CLINCH RIVER NUCLEAR SITE ADVANCED NUCLEAR REACTOR TECHNOLOGY PARK FINAL PROGRAMMATIC ENVIRONMENTAL IMPACT STATEMENT

July 2022

Type of document: Final Programmatic Environmental Impact Statement

Figure 3-10. Average and Range of Hourly Water Temperature in the Tailwater below Melton Hill Dam by Date (data from 2004 and 2008–2021)

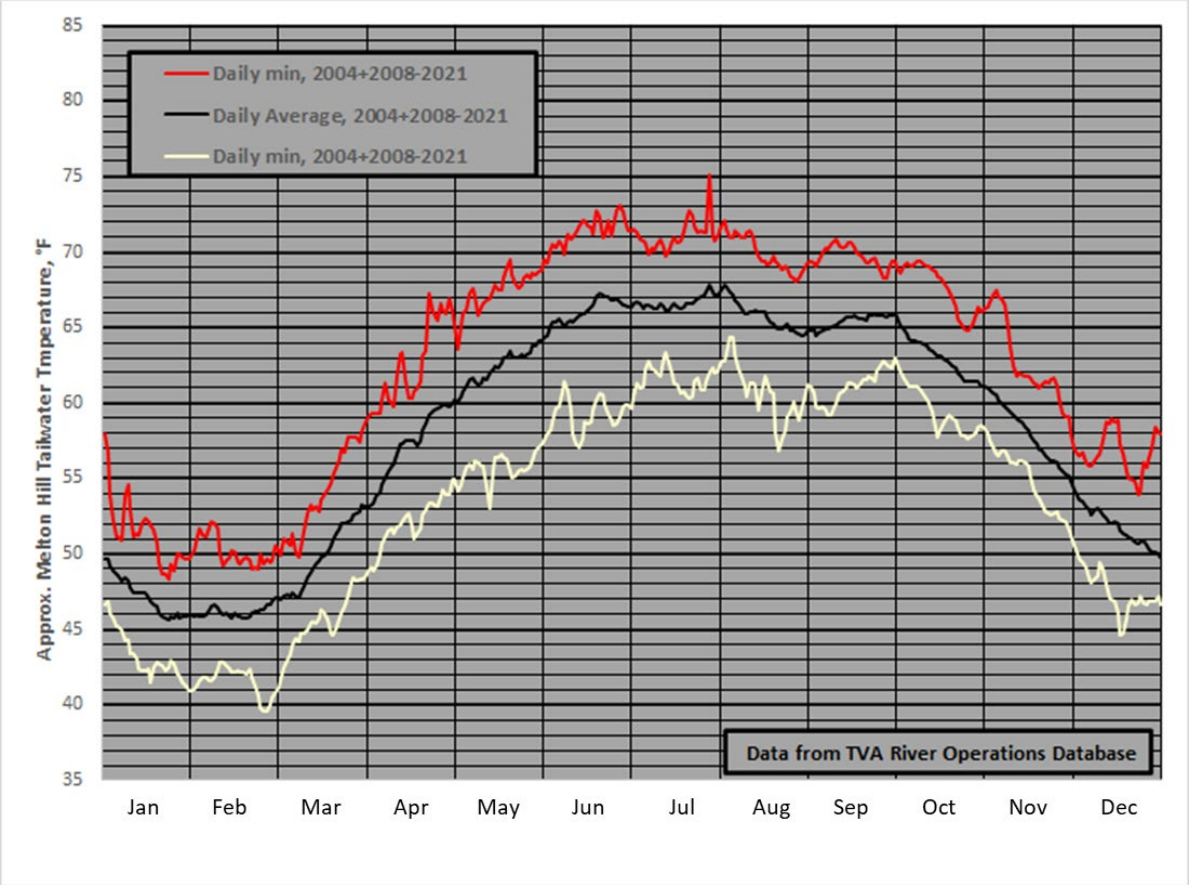
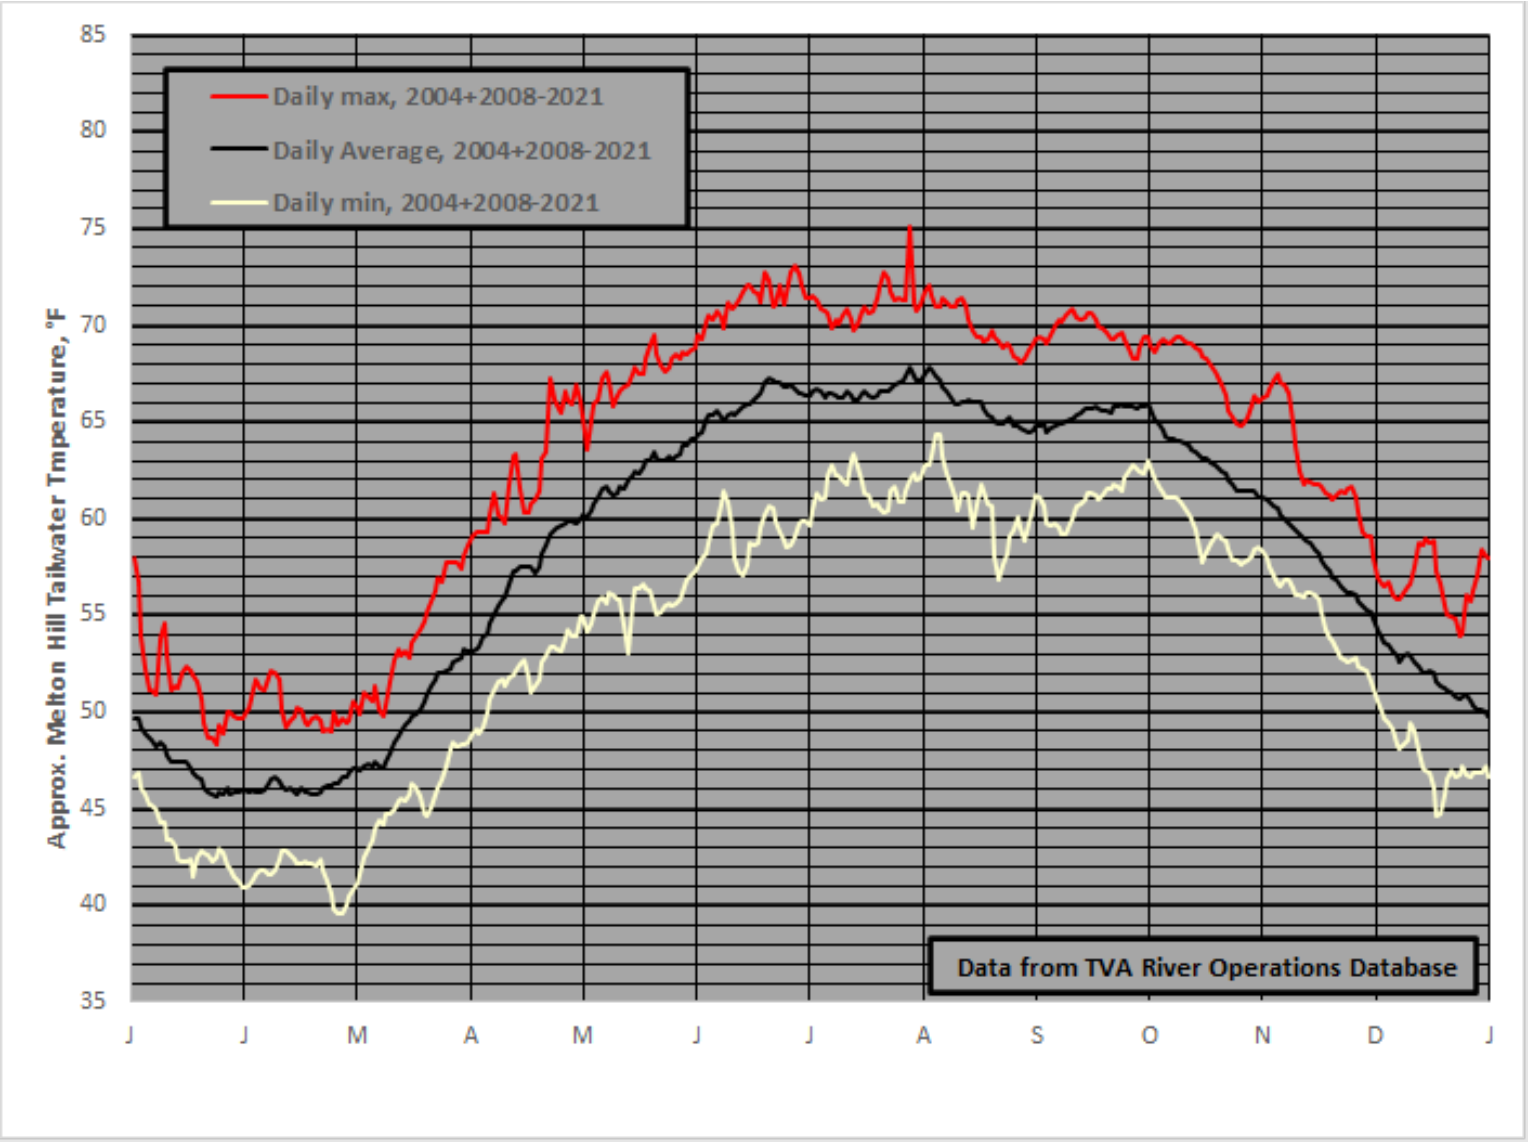
Comment 3: Figure 3-10 on page 88 for "Daily min" temperature should clearly state whether the red line is the maximum temperature.

Revised Figure 3-10
